IEEE P802.15 Wireless Personal Area Networks

Project	IEEE P802.15 Working Group for Wireless Personal Area Networks (WPANs)		
Title	Removing public key suites		
Date Submitted	[January, 2003]		
Source	[Daniel V. Bailey, Ari Singer] [NTRU] [5 Burlington Woods Burlington, MA 01803 USA]	Voice: Fax: E-mail:	[+1 781 418-2522] [+1 781 418-2532] [dbailey@ntru.com]
Re:	802.15.3 TG3 Draft D15 for sponsor ballot		
Abstract	[This document is offered as a set of comments	and recomme	nded changes to 802.15.3 D15.]
Purpose	[This document is intended as support for sponsor ballot comments on 802.15.3 D15.]		
Notice	This document has been prepared to assist the IEEE P802.15. It is offered as a basis for discussion and is not binding on the contributing individual(s) or organization(s). The material in this document is subject to change in form and content after further study. The contributor(s) reserve(s) the right to add, amend or withdraw material contained herein.

This document outlines the changes necessary to remove the public-key suites from 802.15.3.

Figure 9—Key request protocol overview

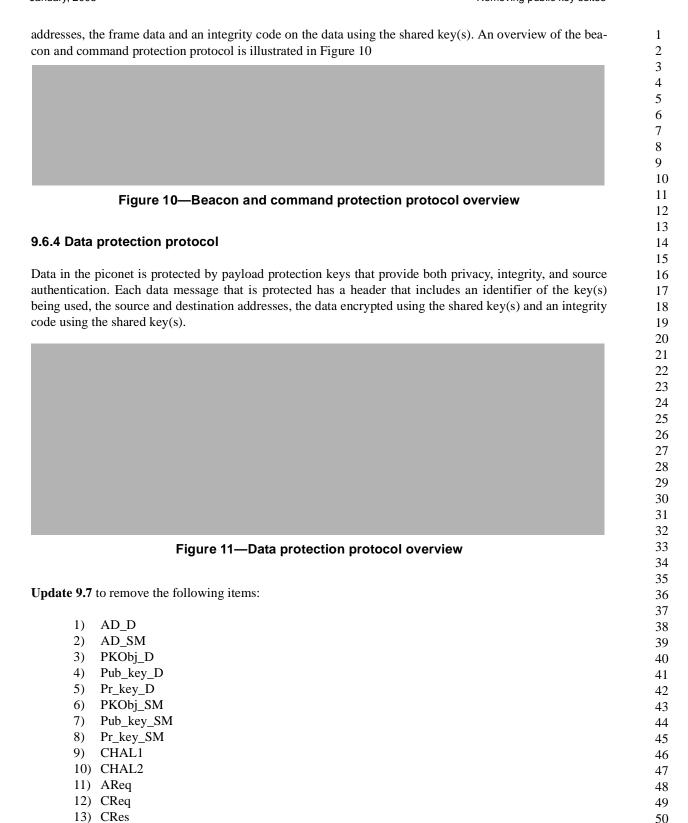
When the security manager updates the piconet protection key, the DEV may not have received the new key properly when it wants to start sending or receiving data. When this occurs, the DEV may request the current key from the security manager. An overview of the key request protocol is illustrated in Figure 9.
